<p>C4/1-13 THE GATEWAY, BROADMEADOWS VICTORIA 3047 PHONE +61 (0) 3 9359 9865, FAX +61 (0) 3 9359 1613. ABN: 82 433 264 489</p>	<p><b>AIRWORTHINESS DIRECTIVE</b> <b>THE GLIDING FEDERATION OF AUSTRALIA Inc</b></p> <p><b>GFA AD 305 Issue 2</b> <b>Date: 27 April 2023</b></p> <p>Note: This Airworthiness Directive is issued by the Gliding Federation of Australia</p>
<b>Type Certificate Holder</b>	Grob Aircraft SE
<b>Manufacturer(s)</b>	Burkhart Grob Luft-und Raumfahrt Gmbh & Co. GROB-Werke GmbH & Co.KG
<b>Types/Models Affected</b>	All G 109B Touring Motor Gliders
<b>Serial Numbers</b>	Serial numbers 6200 to 6434 inclusive.
<b>Subject</b>	Modifications, including rudder system damper, rudder hinge stiffening, and aileron control mass balance.
<b>Implementation</b>	<b>MANDATORY</b>
<b>Background</b>	<p>GFA AD 296, now cancelled, restricted the G 109B to a <math>V_{NE}</math> of 100 knots as a temporary flutter limitation.</p> <p>GFA AD 305 Issue 1 mandated the incorporation of GROB TM 817-20 (which forms part of this AD). This included rudder and aileron control system modifications which, when fully incorporated would allow AD 296 restriction to be lifted, returning the 109B to its normal

**Bilderteil zur Arbeitsanleitung Nr. 817-20/1**  
(Pictures to repair instruction no. 817-20/1)

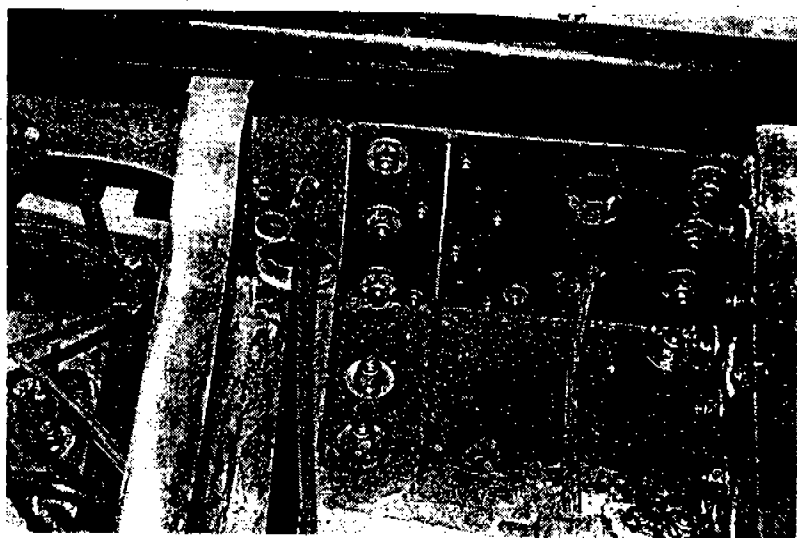
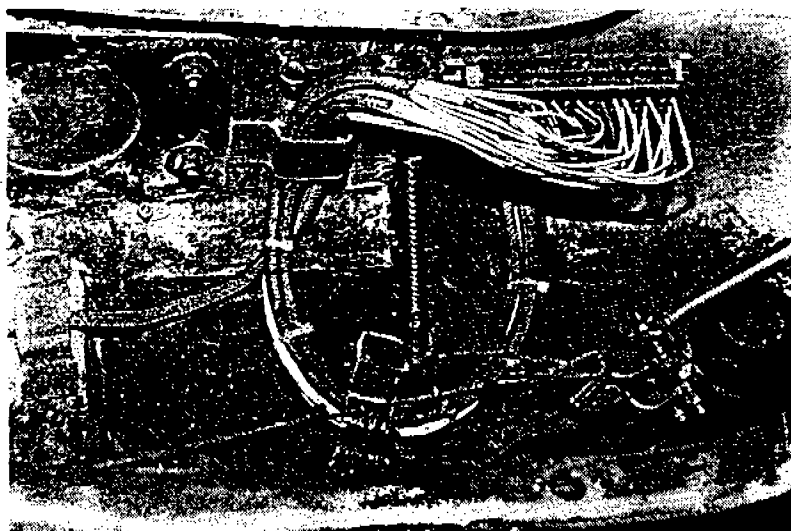
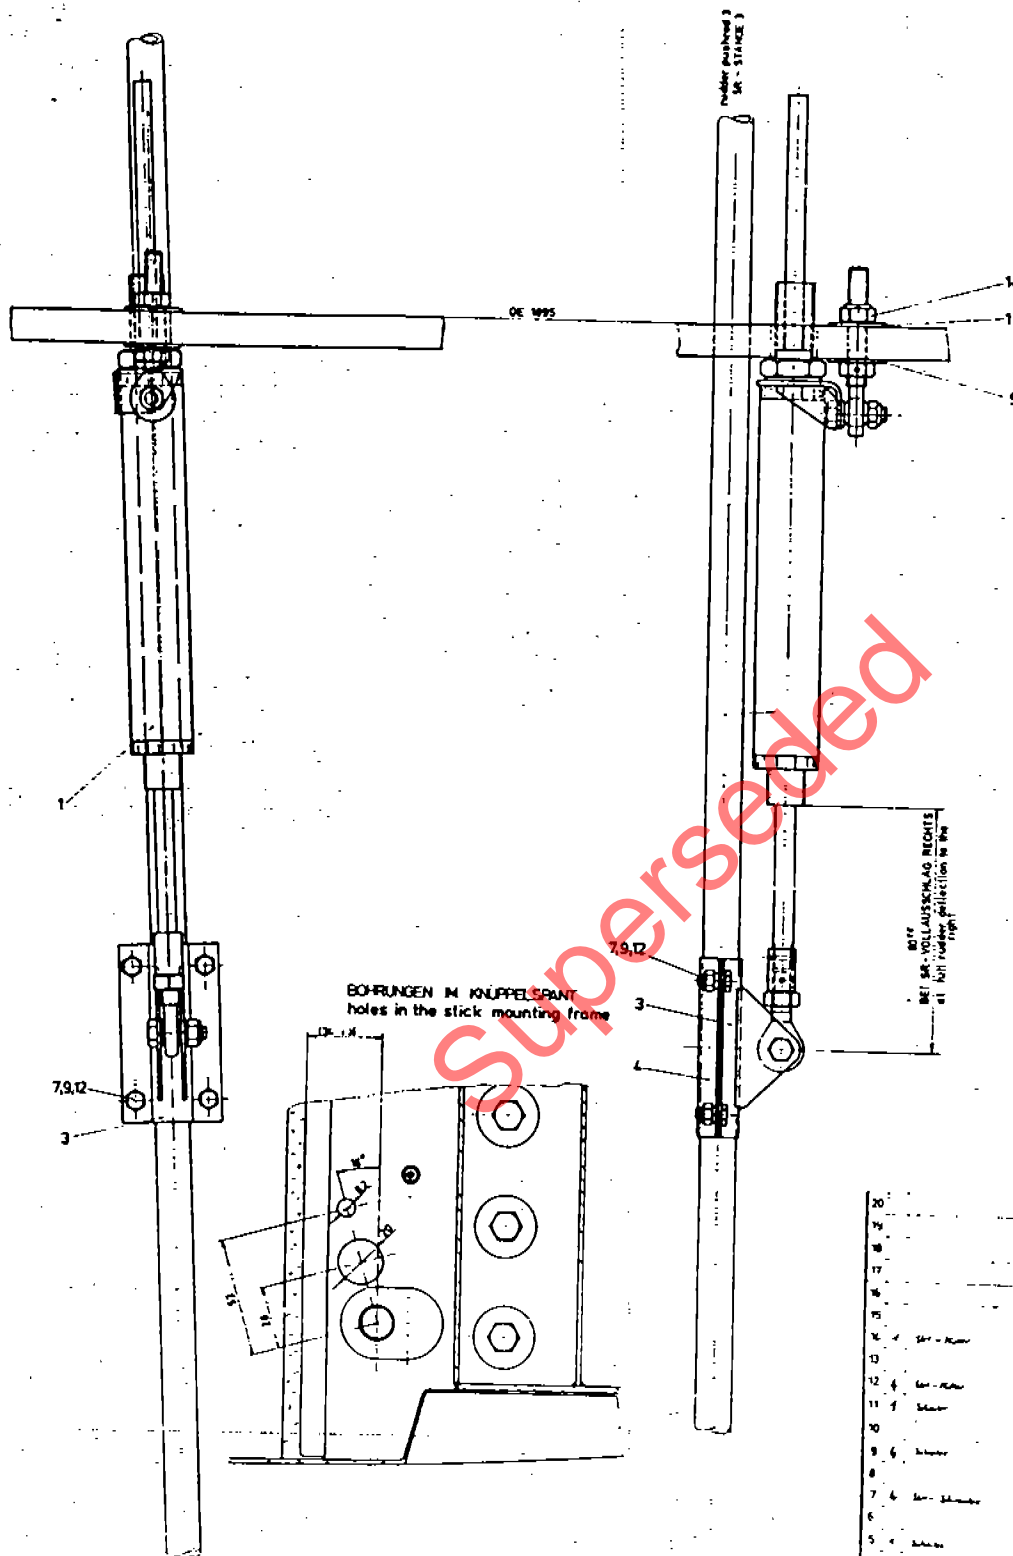
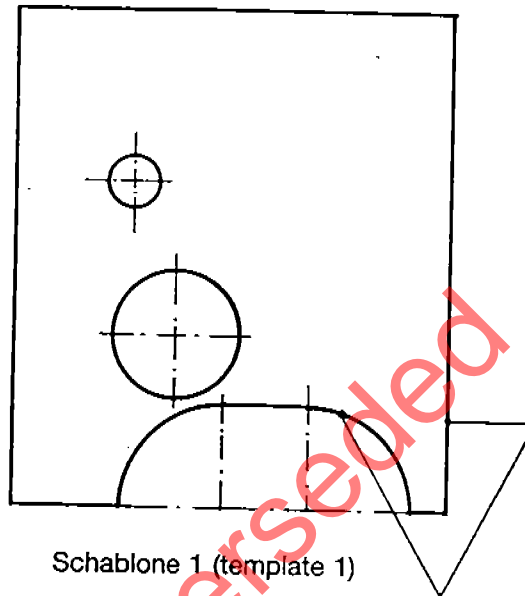
First instruction: Installation of a rudder damper according to Repair Instruction no. 817-20/1.

Repair Instruction No. 817-20/1 to TM 817-20		GROB G 109 B
<p>The installation of the damper will be facilitated by dis-assembling the right wing. Insure that the piston rod of the damper will not be damaged during the installation.</p> <ol style="list-style-type: none"> <li>1. Remove right seat.</li> <li>2. Remove the right ABS plastic cover over the stick mounting frame (4 countersunk screws M4 x 20 DIN 963 with finish washers).</li> <li>3. Locate and drill holes in the stick mounting frame per drawing 109B-4380. To properly locate the holes, cut out template 1 and paste to the stick mounting frame. Insure that the holes are drilled perpendicular to the stick mounting frame (see also fig. 1).</li> <li>4. Preserve holes with resin (Caution! Never use oily preservation agents).</li> <li>5. Mount damper at the stick mounting frame according to pictured drawing 109B-4380. The mounted damper unit is in figure 2. The stop nut (14), the cut disk (5) and the washer (11), included in the delivery, are to be used.</li> <li>6. Loosely connect the lower mounting bracket (4) to the piston rod mounting (3) with the hardware (7,9,12). With full rudder deflection to the right, locate the piston rod mounting unit (3,4) at the dimension shown in drawing 109B-4380 (<math>80 \pm 5</math> mm). Secure the mounting unit hardware (7,9,12). (See also fig. 2).</li> <li>7. <u>Note:</u> Only required for s/n 6200 thru 6339. Mount spiral spring to the airbrake cable according to fig. 3. For that purpose, drill a hole (dia. 2 mm) in the flange of the seat frame cut-out for attachment of the spiral spring (fig. 3). Insure sufficient edge clearance (<math>\geq 5</math> mm). Next the shrink tube should be cut and turned over the airbrake cable. Push the cable clamp over the shrink tube and secure with the spring grommet 109B-5130, hex head screw M4, stop nut M4, and washer 4.3. (Any previously installed spring in this application should be replaced with the above installation.)</li> <li>8. After assembly of the damper perform functional test. In doing so, pay attention to the following: <ul style="list-style-type: none"> <li>- The damper must not be used as rudder stop.</li> <li>- The damper must work without tension in each position of the rudder push rod.</li> <li>- The piston rod of the damper must not have any damages (scores, scratches, etc.).</li> <li>- To prevent jamming of the rudder at full deflection, the dimension (<math>80 \pm 5</math> mm) indicated in point 6 above <u>must</u> be observed.</li> </ul> </li> </ol>

**Bilderteil zur Arbeitsanleitung Nr. 817-20/2**  
(Pictures to repair instruction no. 817-20/2)

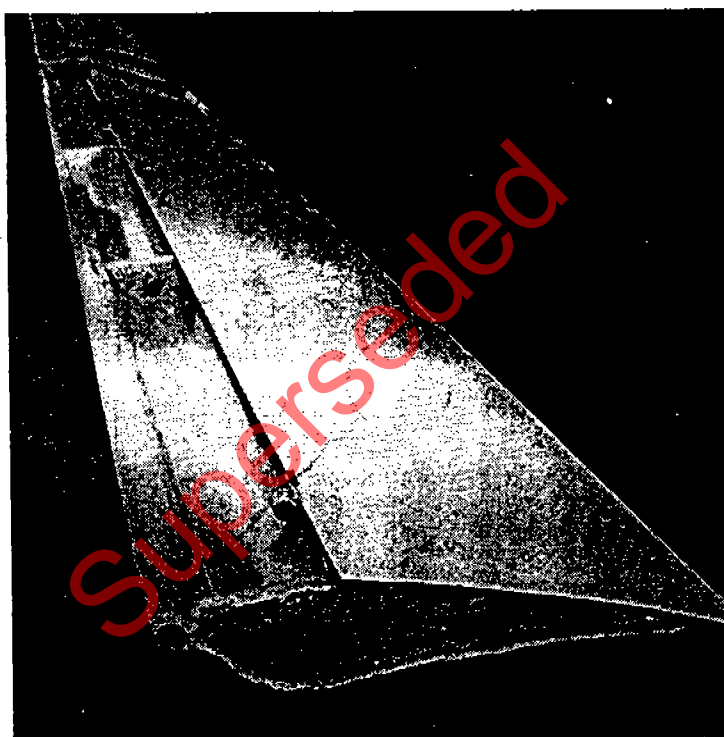
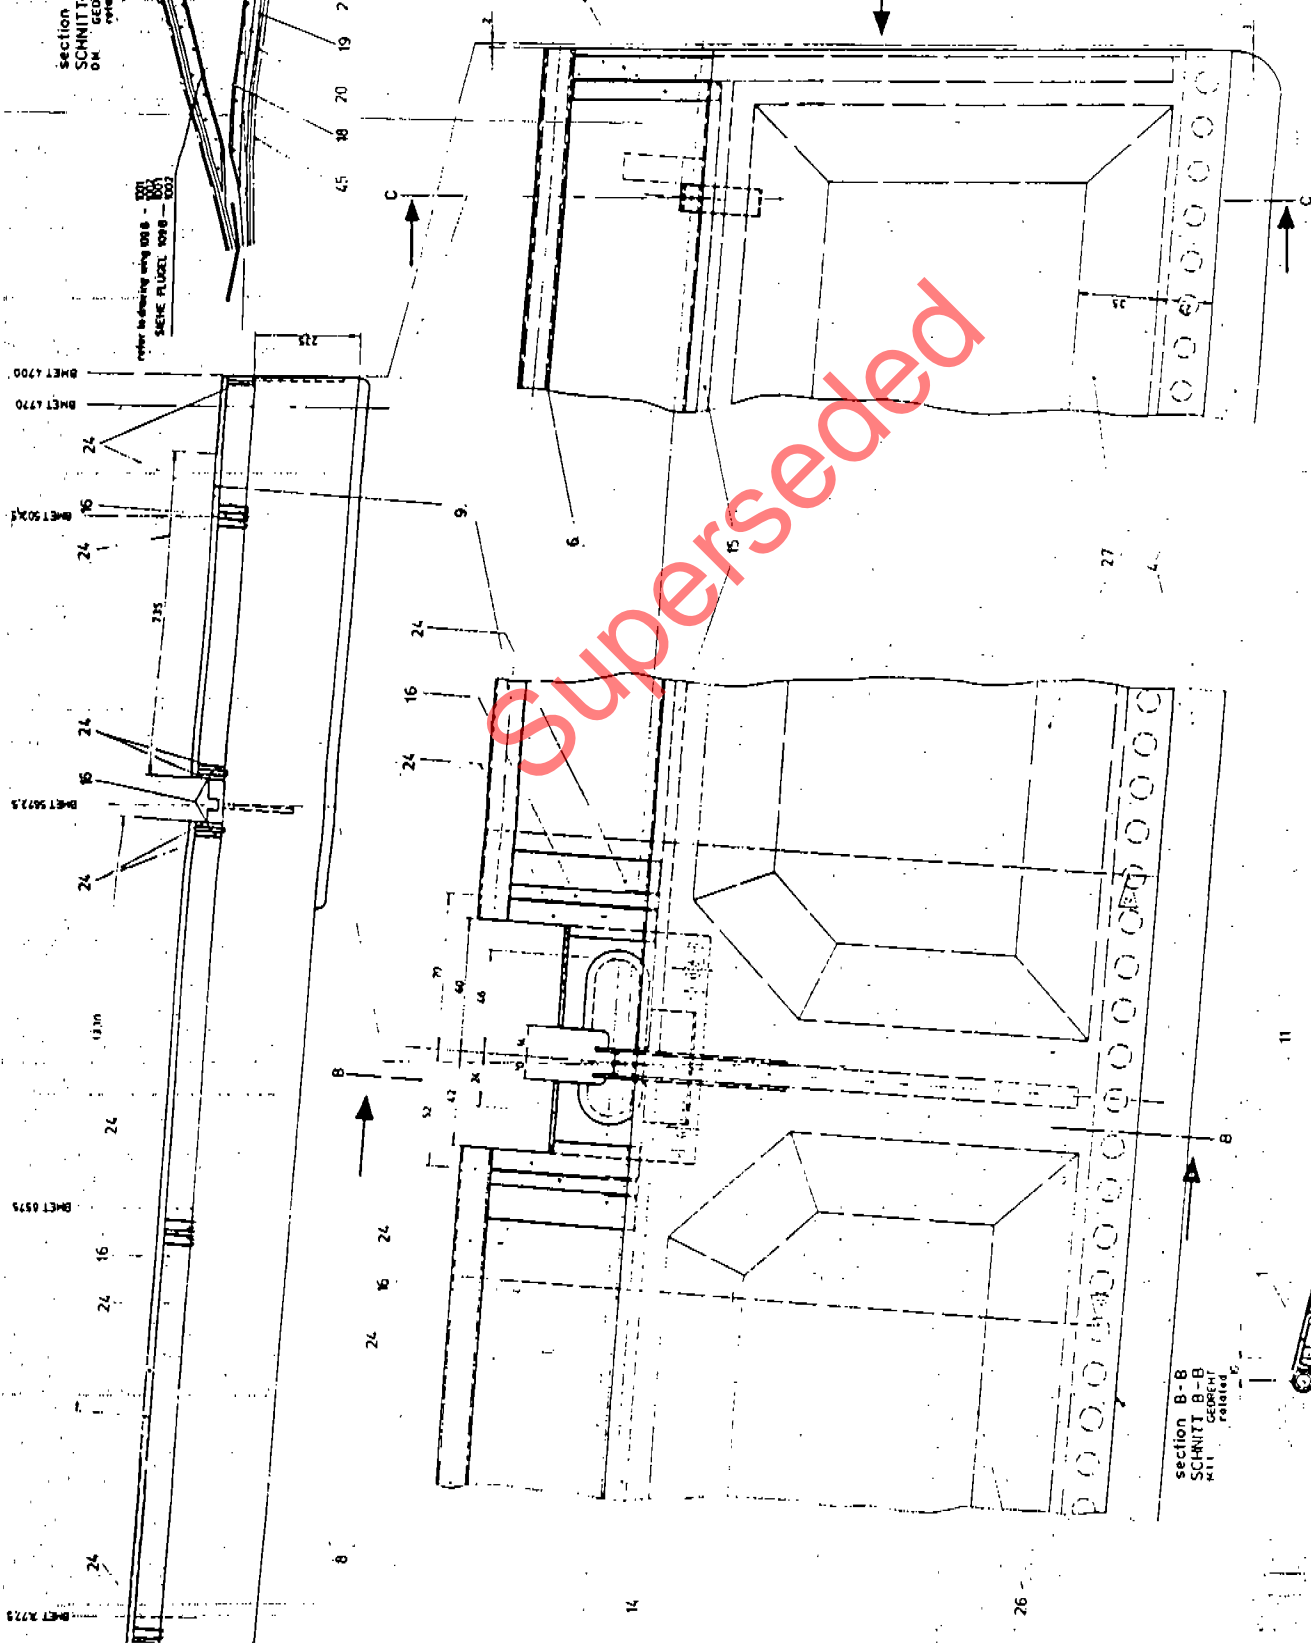
Second instruction: Installation of additional mass-balance in the ailerons according to Repair Instruction no. 817-20/2.

Repair Instruction No. 817-20/2 to TM 817-20		GROB G 109 B
<ol style="list-style-type: none"> <li>5. Remove the aileron hinge pins (4 pieces 6f7 x 28 DIN 1434 galvanized, 1 piece 6f7 x 40 DIN 1434 galvanized) from the aileron bearings. Caution: Pins and aileron bearings belonging together must be marked. Likewise a note concerning the installation direction (pin installed from the right or from the left) should be made.</li> <li>6. Put aileron on supporting stands.</li> <li>7. Grind aileron horn in the region to be laminated on (see drawing 109B-1111/1112 and fig. 1 of pictures).</li> <li>8. Attach two lead rods (ea. 360 mm) (7) with thickened resin-hardener mixture (49) according to drawing 109B-1111/1112. If a screw head or nut from the existing mass balance (5, 10) hinders the attachment of the new lead rods, remove lead from the new rods in the corresponding location with a file. NOTE: In the parts list, the mass balance (7) is specified as lead rod 720 mm long. For reasons of packing, the rod was divided into two halves of 360 mm ea.</li> <li>9. Laminate additional mass balance with 2 layers of glass-cloth LN 8.4551.6 (Interglas no. 92125/) to the aileron horn (29) (see drawing 109B-1111/1112 view A).</li> <li>10. Make an additional stiffening rib (16) from the delivered hard foam piece. (Caution: There must be made 2 stiffening ribs from this hard foam piece - aileron left and right). The stiffening rib is to be fitted to the aileron horn at the indicated place according to drawing 109B-1111/1112. The stiffening rib is to be glassed into place on both sides, each with 2 layers of glass-cloth 92125 (24). After hardening, a drainage hole (see also fig. 1 of pictures) with a diameter of 6 mm must be installed.</li> <li>11. The points 2. thru 10. must be carried out for the second aileron, also.</li> <li>12. After hardening, the weight and the residual moment of both ailerons must be determined according to maintenance manual G 109 B, page 28 (new manual page dated Jan. 29, 86). In all cases, the indicated limiting values must be observed. (Residual moment 17,5 kgcm <math>\pm</math> 15 %, weight 9,5 kg <math>\pm</math> 15 %)</li> </ol> <p>If the residual moment is too high, it is possible to install additional lead at the indicated location (40,43); but only if the weight of the aileron does not yet exceed at the upper limit. The necessary material must be obtained from the manufacturer with information of measured aileron weight and residual moment.</p>

(Pictures to repair instruction no. 817-20/3)

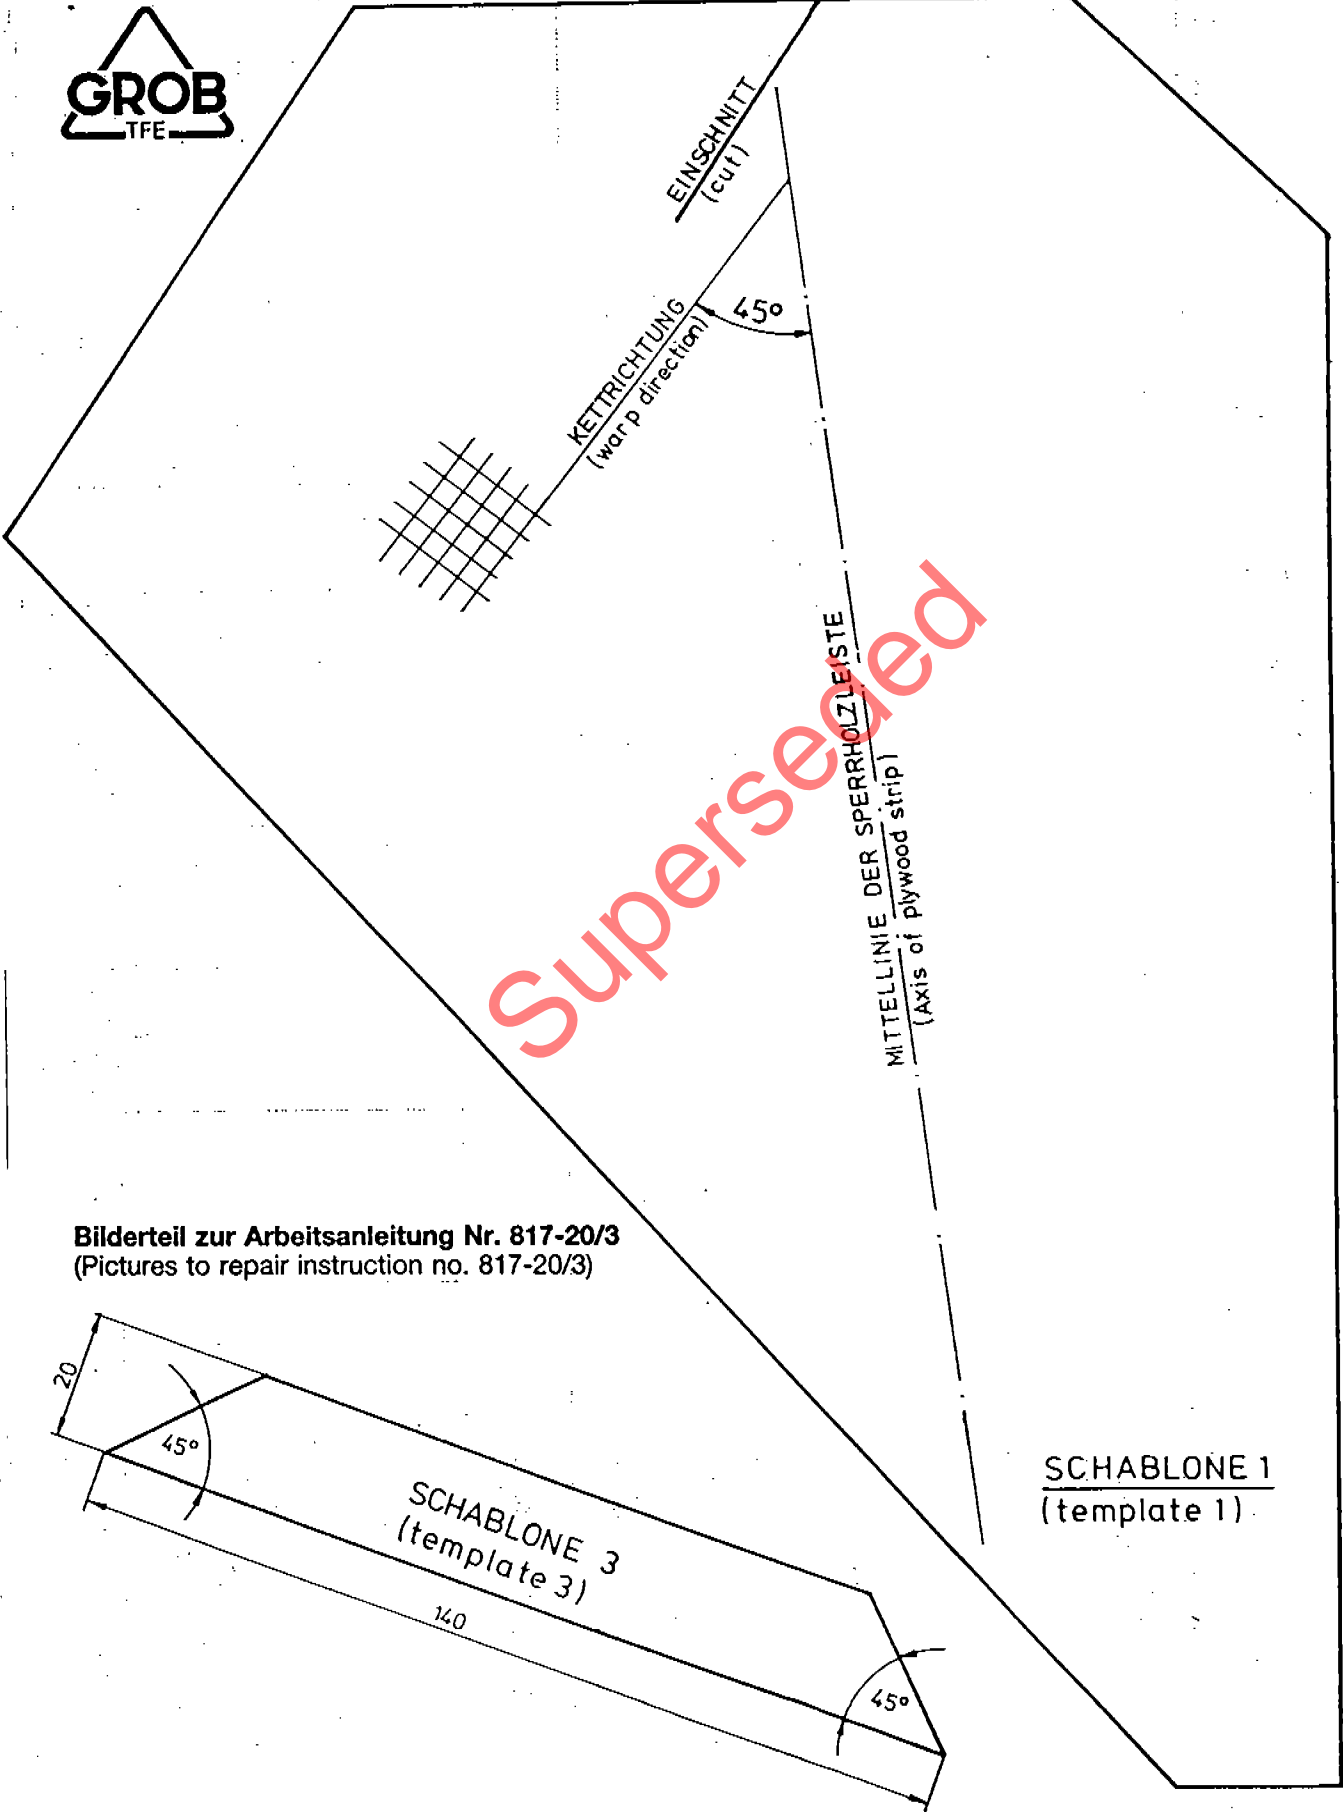
Third instruction: Stiffening of the upper and lower rudder suspension at the fuselage according to Repair Instruction no. 817-20/3.

<p>Repair Instruction No. 817-20/3</p> <p>to TM 817-20</p>		<p>GROB G 109 B</p>
<p>The Repair Instruction no. 817-20/3 pertains to the Technical Information TM 817-20 and describes the stiffening of the upper and lower rudder suspension at the fuselage:</p> <p><b>Material:</b></p> <ul style="list-style-type: none"> <li>1 Repair instruction no. 817-20/3</li> <li>3 Templates for the wood and glass-cloth</li> <li>2 Plywood strips 20 x 3 x 140</li> <li>2 Hexagon nuts M6 LN 9348</li> <li>- Glass-cloth LN 8.4554.6 (Interglas 92140) 400 x 1000 mm</li> </ul> <p><b>Tools:</b></p> <ul style="list-style-type: none"> <li>1 Engineer's wrench 10 mm</li> <li>1 Socket 10 mm</li> <li>1 Allen wrench size 5 mm</li> <li>Abrasive paper coarse-grained (i.e. 80)</li> <li>1 Long nose plier</li> </ul> <p><b>Note:</b> (see note of Repair Instruction 817-20/1)</p> <ol style="list-style-type: none"> <li>1. Remove the adhesive tape from the rudder hinge line. Next, remove the hardware at the lower rudder hinge (internal wrenching cap screw M6 x 70 DIN 912, stop nut M6 LN 9348, washer 6,4 LN 9025). With the rudder at full left deflection and slightly aft, remove the rudder pushrod connection (hex head screw M6 x 30 LN 9037, stop nut M6 LN 9348, washer 6,4 LN 9025). The rudder can now be carefully lifted off of the top hinge pin and away from the fuselage. CAUTION: A/C with nav and/or strobe lighting must have their wiring disconnected upon rudder-removal. Insure that the wiring does not fall into the rudder.</li> <li>2. Grind the region to be stiffened. <ul style="list-style-type: none"> <li>- upper rudder bearing see fig. 1 (pictures)</li> <li>- lower rudder bearing see fig. 2 (pictures)</li> </ul> </li> <li>3. Cut the delivered glass-cloth to size by the aid of template 1 (valid for upper rudder bearing) and template 2 (valid for lower rudder bearing). Pay attention to the warp direction (see respective template). For upper and lower rudder bearing 3 layers of glass-cloth Interglas 92140 are required for each.</li> <li>4. Cut the plywood strips included in the delivery according to template 3.</li> <li>5. Fix plywood strips with thickened resin-hardener mixture at the assigned places (rudder bearing above and below) (see also fig. 1 and 2).</li> <li>6. Laminate glass-cloth according to fig. 1 and 2 over the plywood strips.</li> </ol>
